The Heights Building Phase 2

Transportation Commission – June 30, 2022

Planning Commission – July 7, 2022

Design Revisions

Plan View: Field (Heights Level 1)

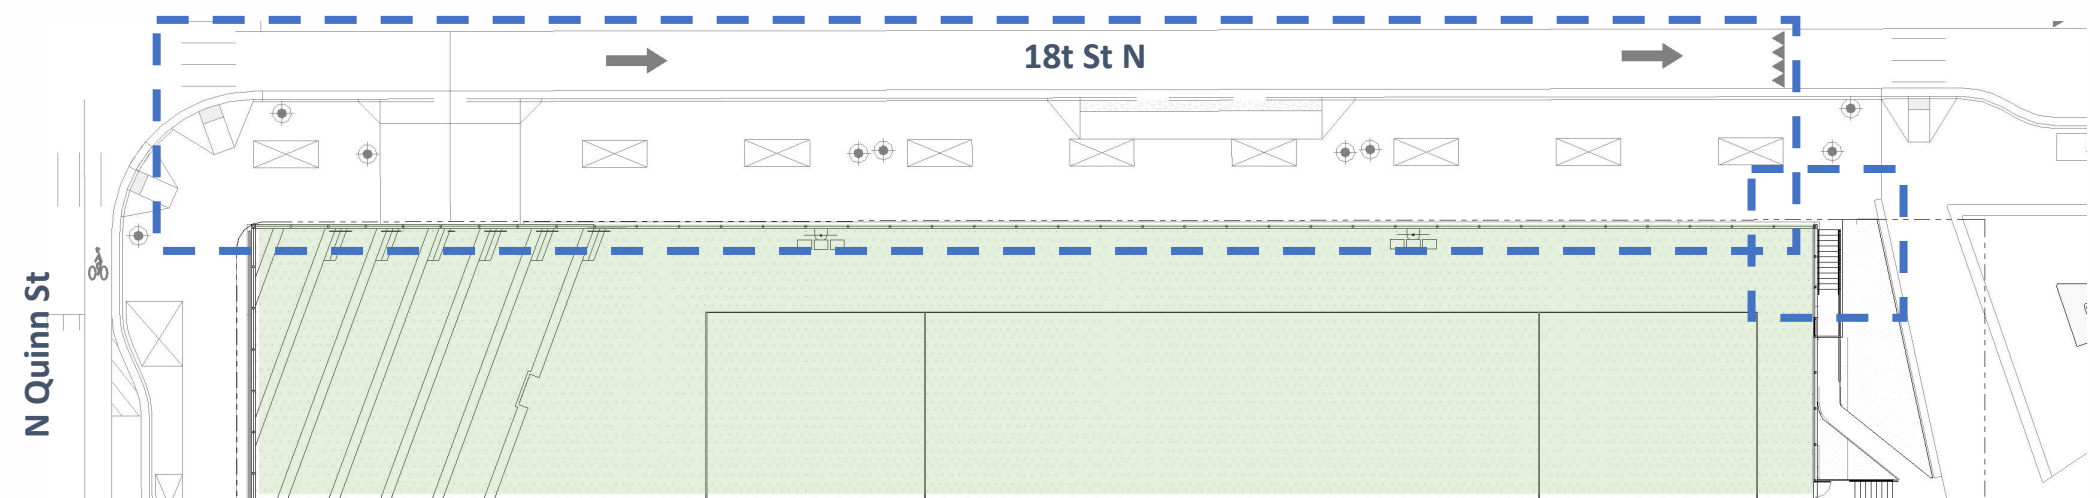
- Revised 18th St N streetscape
 - Maintains existing street width and parking lane adjacent to APS frontage
 - Adds continuous elevated planting strip with trees and other plantings
 - Reduces sidewalk clear width to 10'-0"
- Geometry change at stair from 18th St N to field
- Additional detail on finishes at covered entrance to building Level G1
- Façade treatments along 18th St N
- Added planting strip at N Quinn St adjacent to railing

Enlarged Site Section at 18th St. Near Park

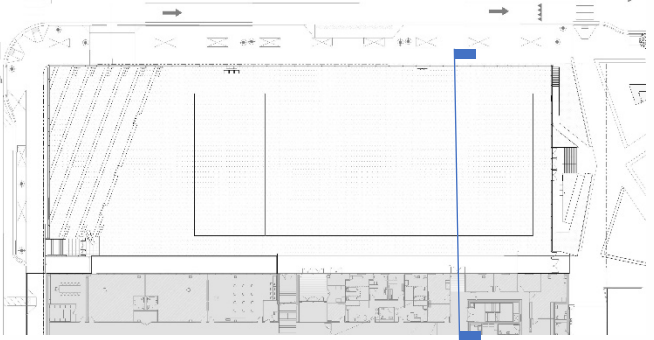
Reduces existing roadway width, removing parking lane along APS frontage

Maintains existing roadway width and parking lane along APS frontage

Covered Entrance to Building Level G1

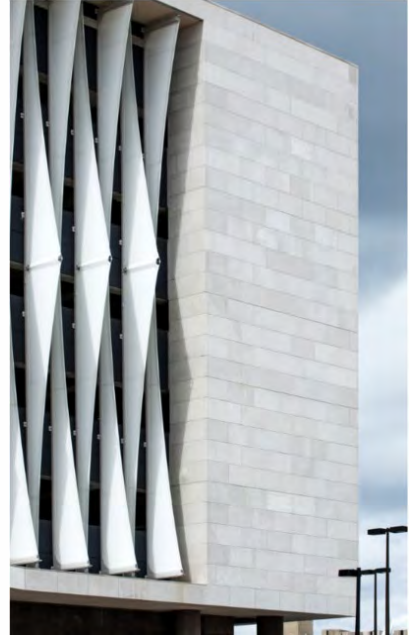
Proposal: a high-quality white mineral coating applied to the concrete wall and soffit at covered entrance.
